## Certified Action of the City of Raleigh Planning Commission

**Case File / Name:** SP-36-11 / West Apartments

## Staff Report

SP-36-11 West Apartments – Preliminary Site Plan -Level One

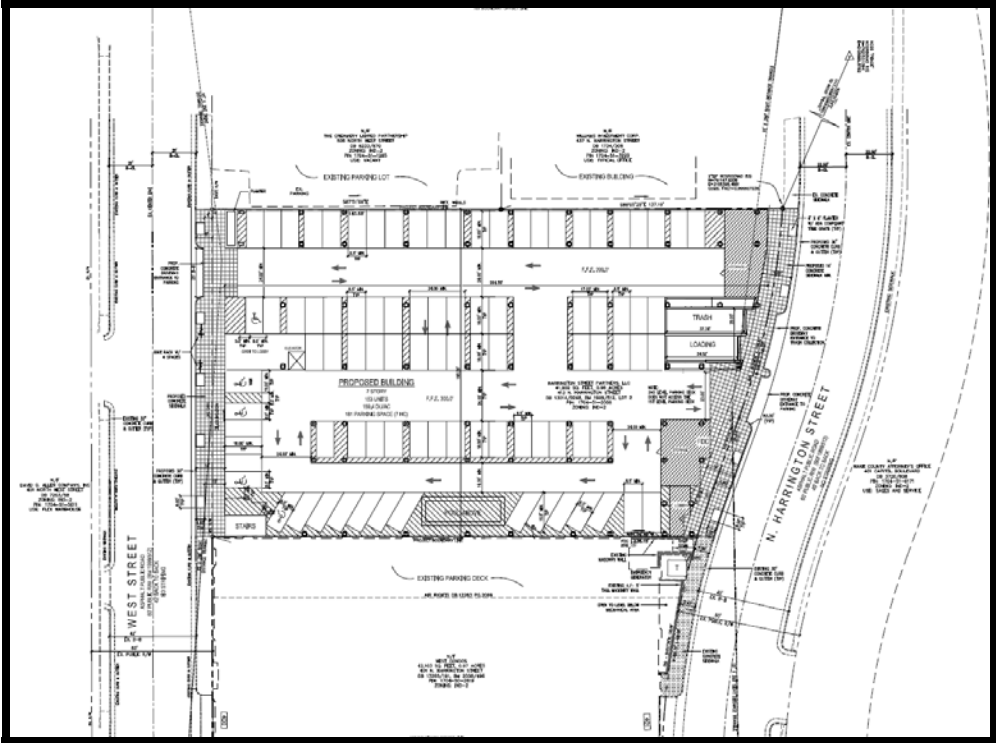
Comment	Response
1) The committee recommends that, in view of the richness of design and articulation exhibited by the other building elevations, similar care be shown on the N. Harrington Street façade, especially at the pedestrian level [commensurate with Code Sec. 10-2132.2(d)(2)].	The ground level treatment of the Harrington Street façade is similar to that of West Street. The building has recessed masonry banding and decorative gates as shown on the elevation. A pedestrian entrance has also been added to articulate the façade.

2) Add vertical screening elements across open parking deck spaces facing N. West and N. Harrington streets [commensurate with Code Sec. 10-2132.2(d)(2)].	No parking will be exposed on the ground level of either street. The parking spaces on the second level are screened by awnings similar to the adjacent West building.

3) Provide opaque screening elements at the top of parking deck openings to reduce glare from internal lighting [commensurate with Code Sec. 10-2132.2(d)(2)].	See response above.

4) Emphasize building entrances through enhancing their	The building entrances have been articulated.

architectural treatment  
[commensurate with Code Sec.  
10-2132.2(d)(2)].

- 5) Add color, detail, variation, and interest to wall facades that are windowless at property lines [commensurate with Code Sec. 10-2132.2(d)(2)].

Detail has been provided through the arrangement of panel joints, and the provision of a detailed masonry façade.
